Technical Service Bulletin

Subject: POOR AIR CONDITIONING PERFORMANCE AND OPERATION	Bulletin No.: 07-004/19
	Last Issued: 09/10/2019

2016-2017 CX-9 vehicles with VINs lower than JM3TC*****142099 (produced before May 19, 2017)

B - Protective Tape, C - Tabs, D - Dashboard

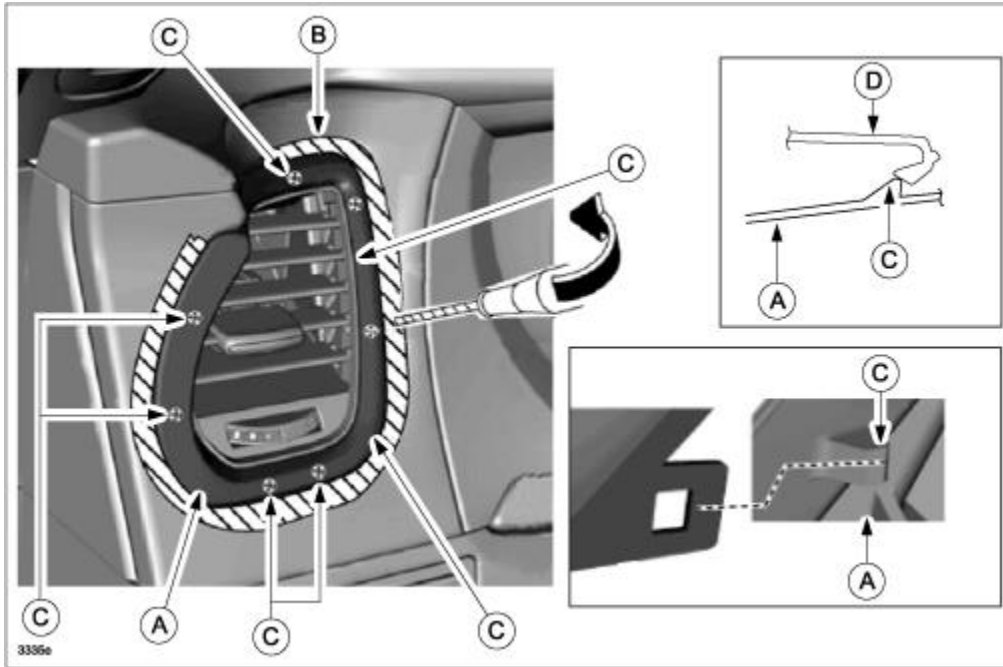
8. (FOR ALL VEHICLES TYPES) Replace the side ventilator grills (A) with modified ones according to the instructions on MGSS online (VENTILATOR GRILLE REMOVAL/INSTALLATION).

For 1) and 2), the front and rear climate control unit software has been modified to optimize the amount of air blown and the A/C compressor ON/OFF controls. For 3), the inner configuration of the side ventilation grilles has been changed to widen the adjustable range.
